UNITED STATES PATENT AND TRADEMARK OFFICE

APPLICATION NO.	FILING DATE	FIRST NAMED INVENTOR	ATTORNEY DOCKET NO.	CONFIRMATION NO.
10/730,191	11/26/2003	Harry F. Schramm JR.	MFS-31944-1	2145
30698	7590	07/12/2005	EXAMINER	
NASA/MARSHALL SPACE FLIGHT CENTER			LEE, SEUNG H	
LSO1/OFFICE OF CHIEF COUNSEL			ART UNIT	
MSFC, AL 35812			PAPER NUMBER

Office Action Summary

DETAILED ACTION

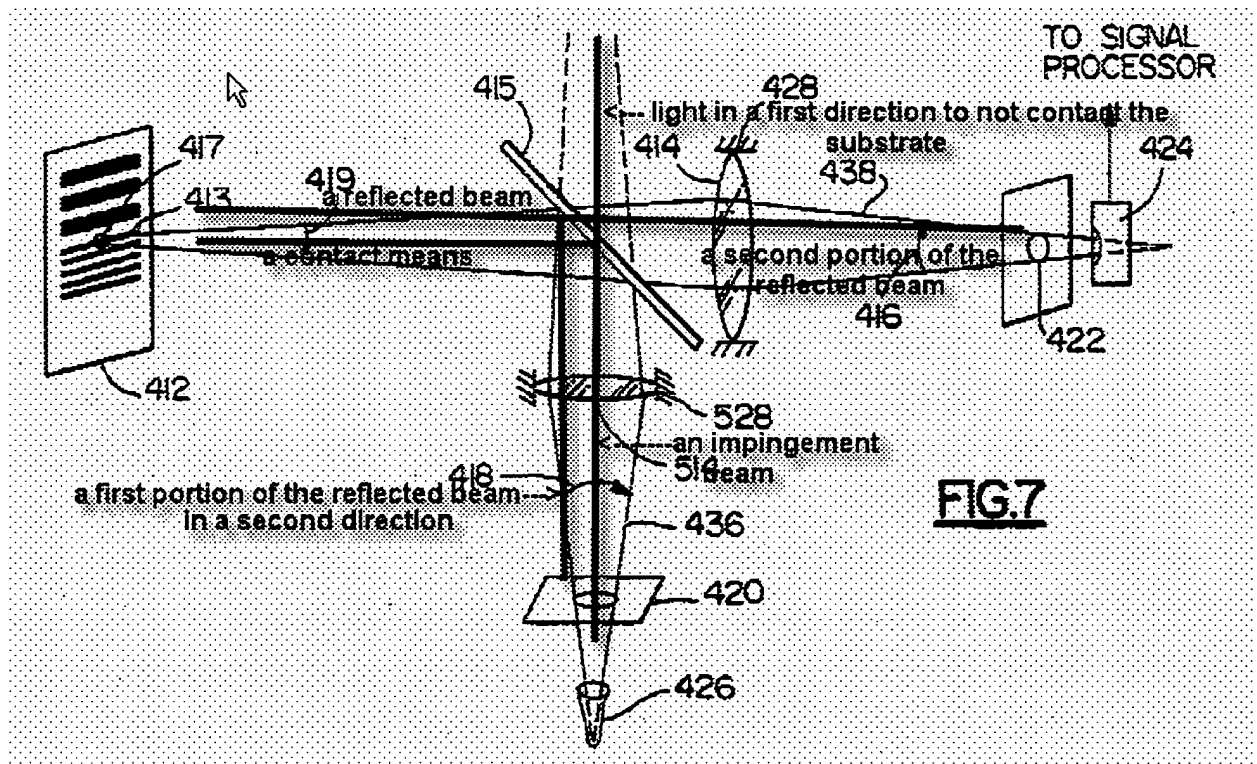
Re claims 1-3, 10, and 15-19: Hammond teaches that a barcode scanner comprises a light source (426) providing an impingement beam, a beam splitter (415) for receiving the light beam from the light source and splitting to allow some light from the impingement beam directing to the substrate (412) as contact beams while allowing some light to pass through the beam splitter in a first direction not to contact the substrate wherein such beam will be lost (i.e., function as a 50/50 mirror), a reflected beam proceedings 180 degrees relative to the contact beams from the substrate, the reflected beam proceeding into the beam splitter wherein a first portion of the reflected beam is directed in a second direction 180 degrees to the first direction and a second portion of the reflected beam passes though the beam splitter, a lens (414) positioned relative to the beam splitter to receive the second portion of the reflected beam, a sensor (424) located opposite of the kens from the beam splitter for receiving the

reflected beam after the reflected beam passes through the lens, the lens, beam splitter and substrate are collinear, the substrate is angled to a plane perpendicular to the contact beam about zero degrees as shown below (see figs. 1 and 7; col. 4, lines 30- col. 6, line 36).
